RE: ENGINEER CERTIFICATION FOR KLINGER CONSTRUCTION (C17-D1U7) ENGINEER  
CERTIFICATION STATEMENT DATED 4/23/93.

RE: Grading & Drainage for Klinger Constructors, Inc.  
8701 Washington, NE - Zone Atlas Page C-17

## Klinger Expansion

***RE: KLINGER EXPANSION, TRACT J, CLIFFORD INDUSTRIAL PARK (C17-D1U7).  
DRAINAGE REPORT AND GRADING PLAN FOR GRADING PERMIT AND  
BUILDING PERMIT APPROVALS. ENGINEER'S STAMP DATED MAY 22, 2001.***

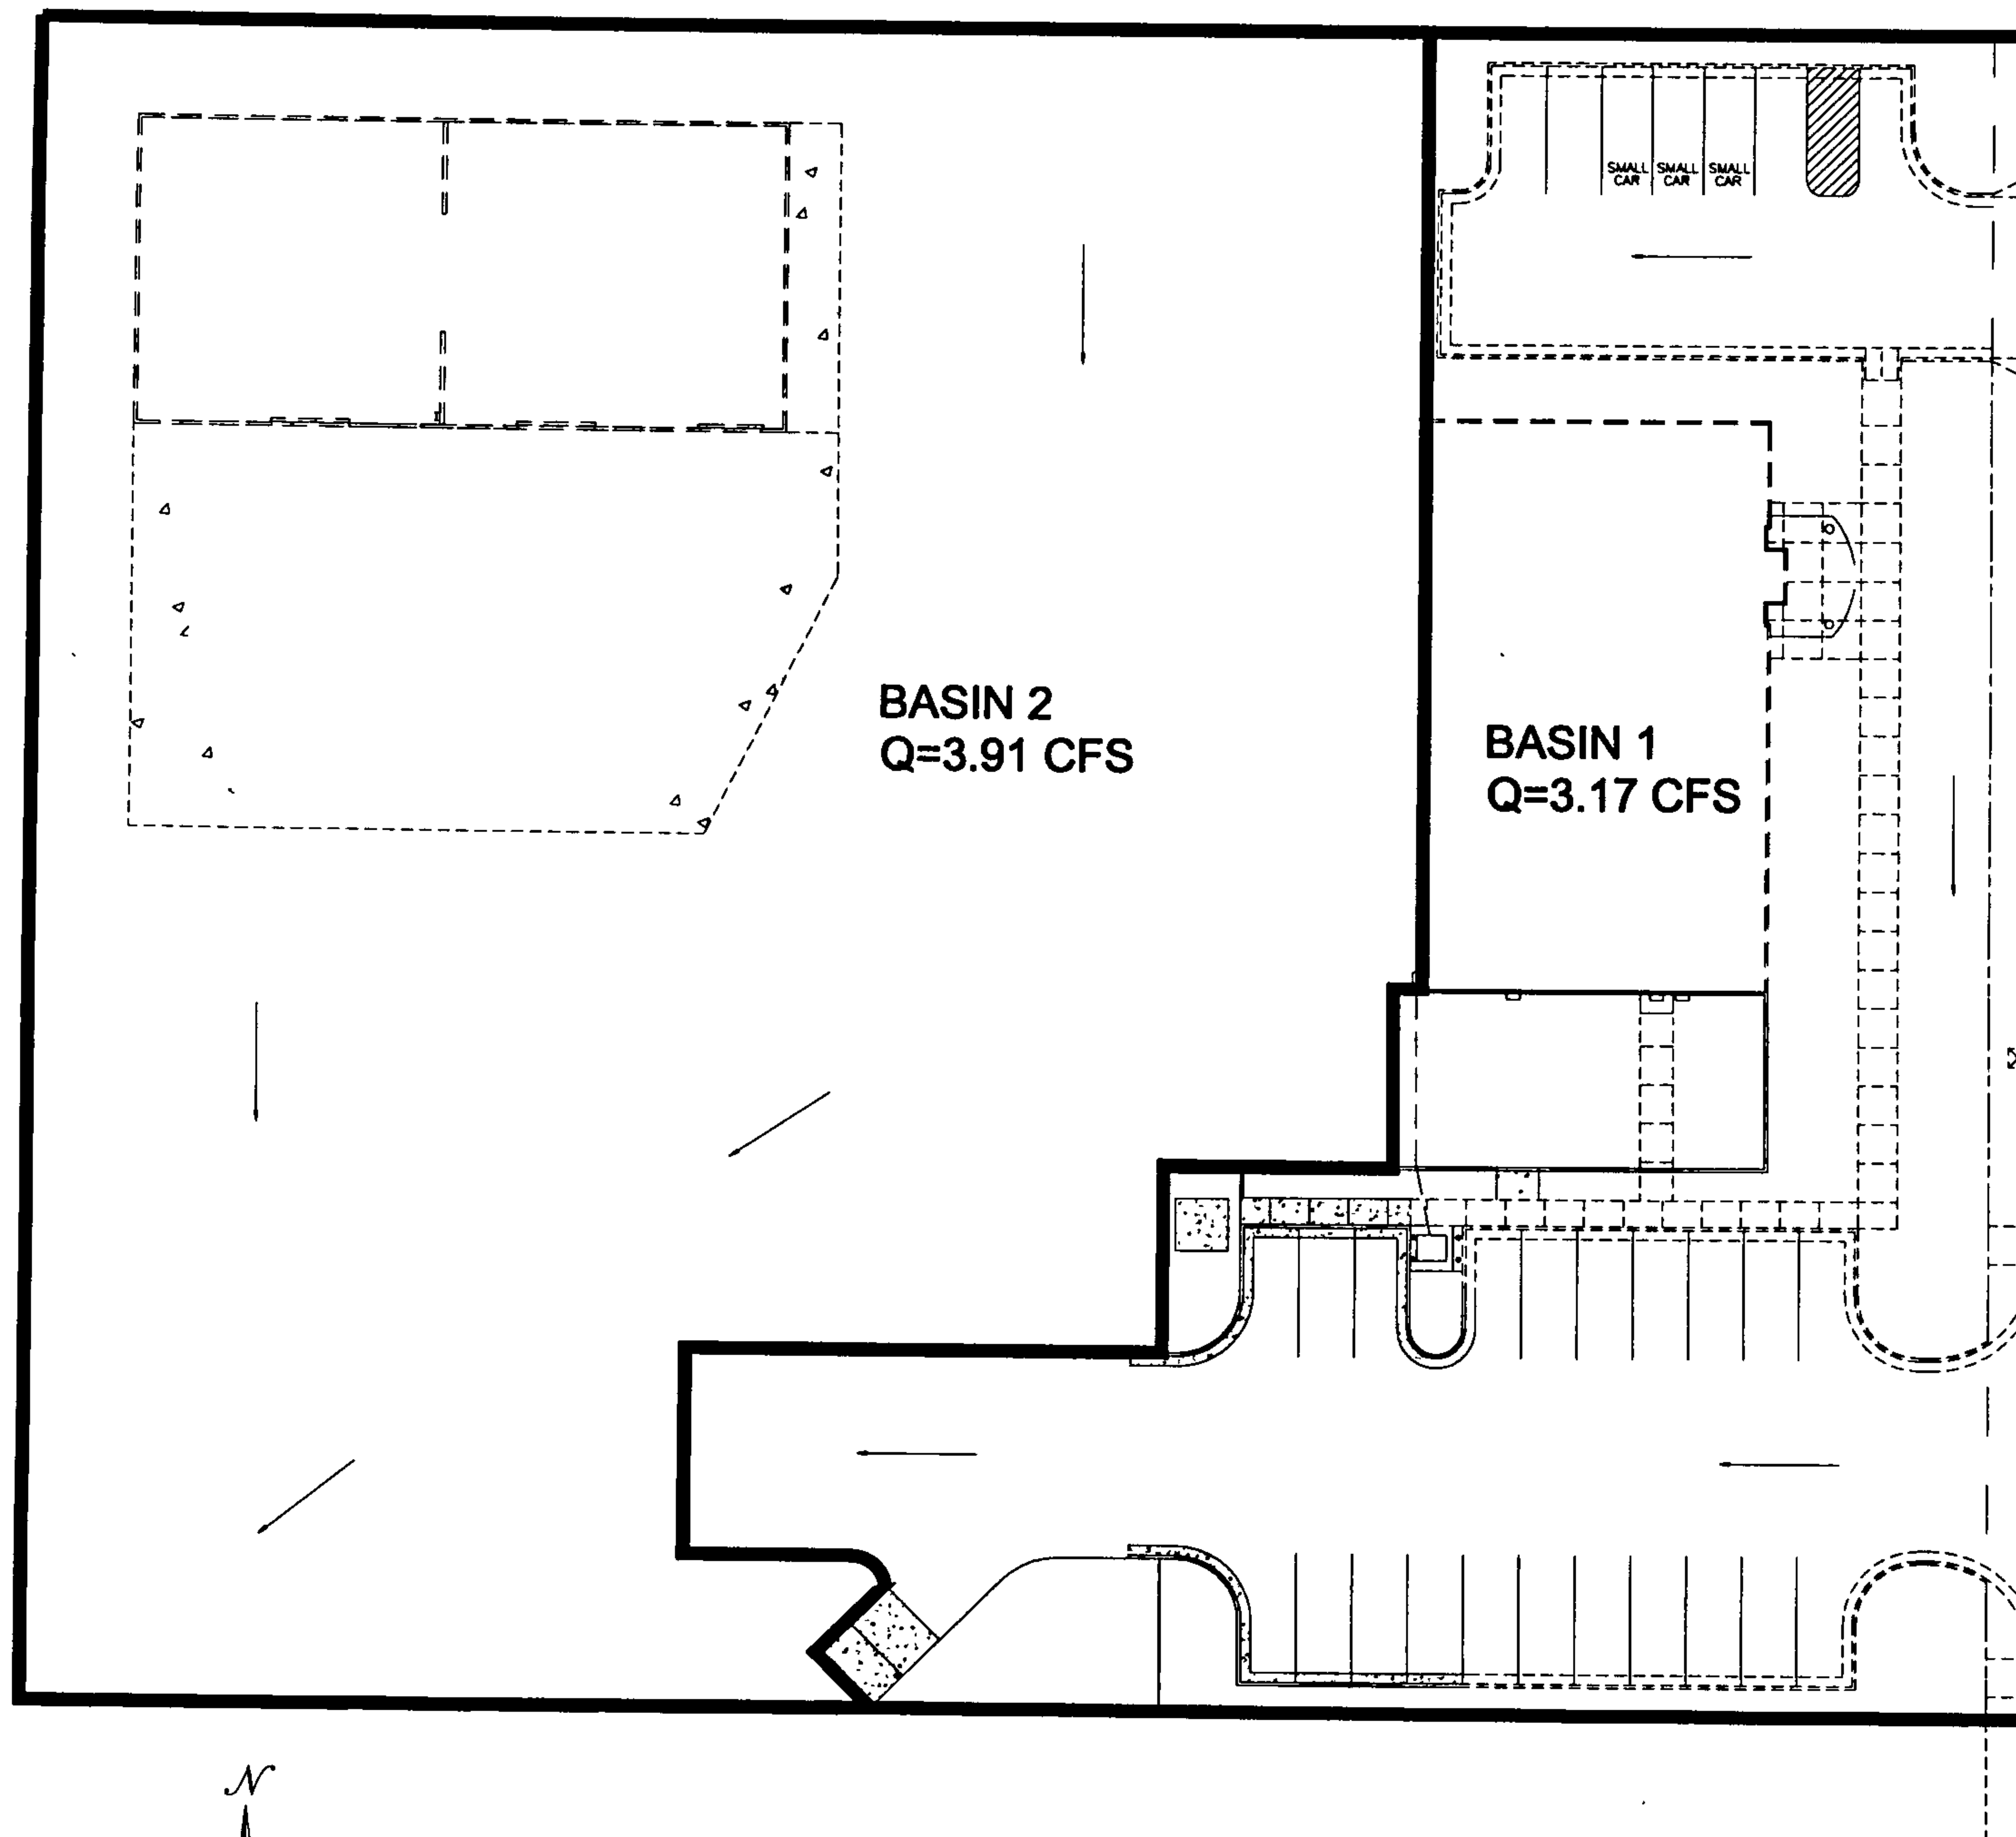
VERBAL CMTS. on 4/23/93  
Engineer Certification statement  
must be on the plan drawing. Bm
